From: Bruce Ott [bruce.ott@amec.com]
Sent: Monday, November 01, 2004 10:05 AM
To: dosmond@gartnerlee.com
Cc: ksexsmith@srk.com; missal@tahera.com; licensing@nwb.nunavut.ca
Subject: Detection Limits for Copper Influencing Carat Lake Average Concentration for Copper

From: Bruce Ott [bruce.ott@amec.com]
Sent: Monday, November 01, 2004 9:28 AM
To: dosmond@gartnerlee.com
Cc: licensing@nwb.nunavut.ca; missal@tahera.com
Subject: Bathymetric Map of Lake C3

Subject **Bathymetry of Lake C3**

Figure 3.3 Bathymetric map of Lake C3,
Jericho Study Area, 2000.

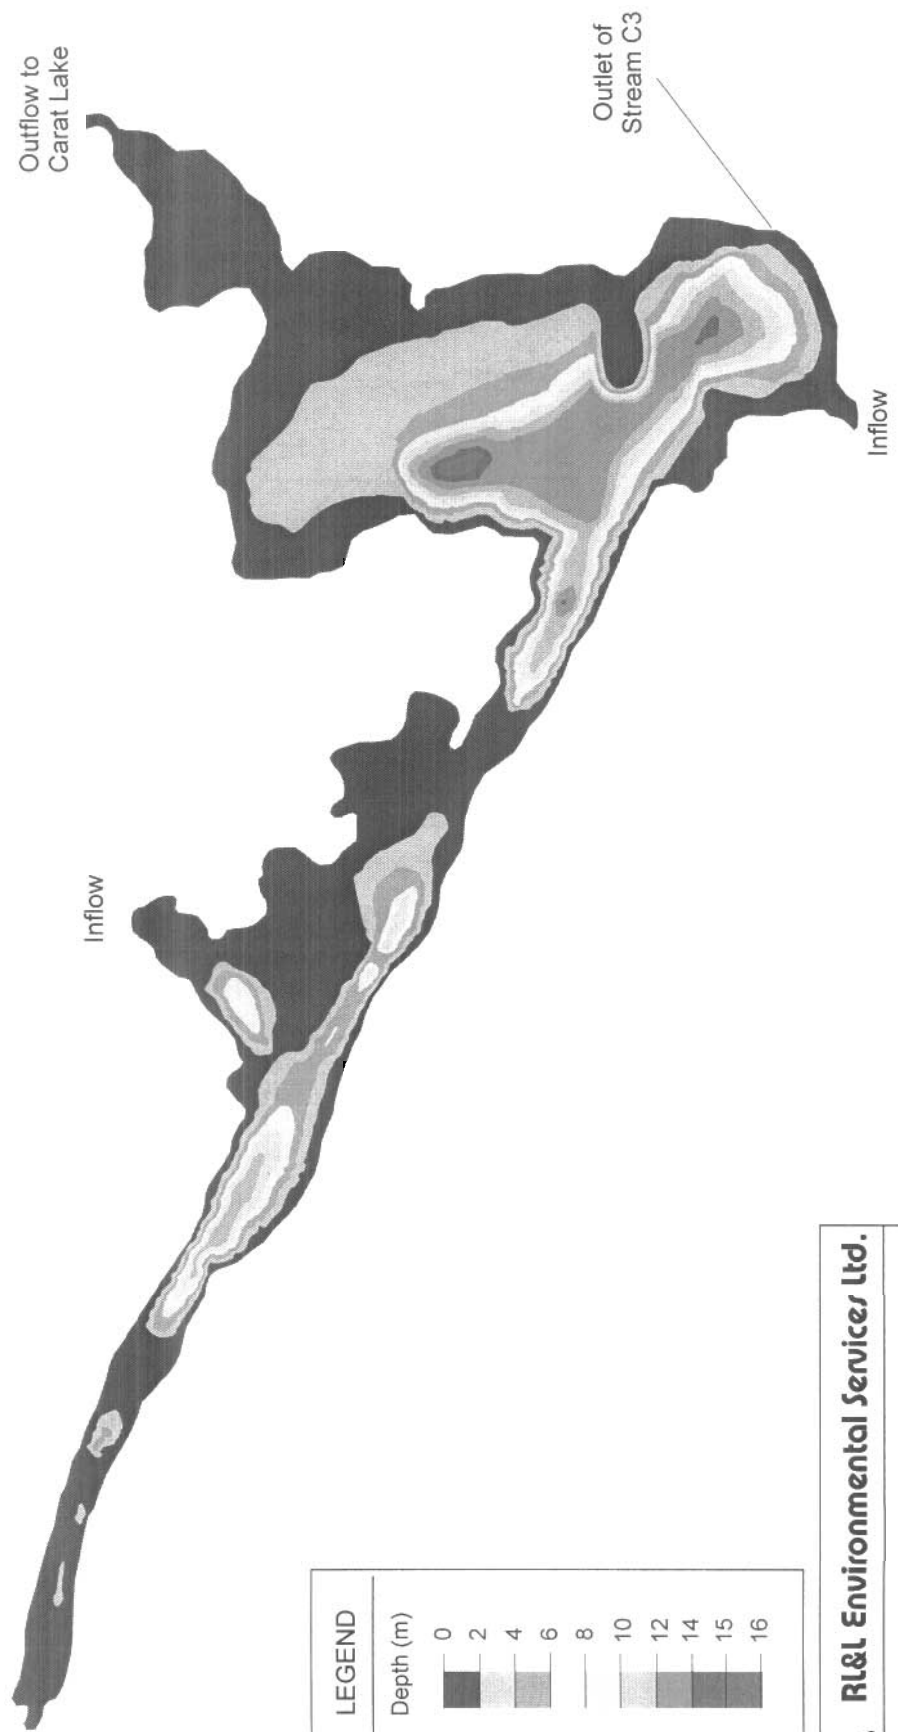
As requested at the 28 October 2004 Jericho Diamond Project workshop in Kugluktuk, I have attached a copy of the bathymetry of Lake C3 produced from surveys conducted by RL&L in 2001. We are not proposing to move SNP5 as the mixing zone is dynamic and a fixed point will not be guaranteed to be at the edge of the mixing zone.
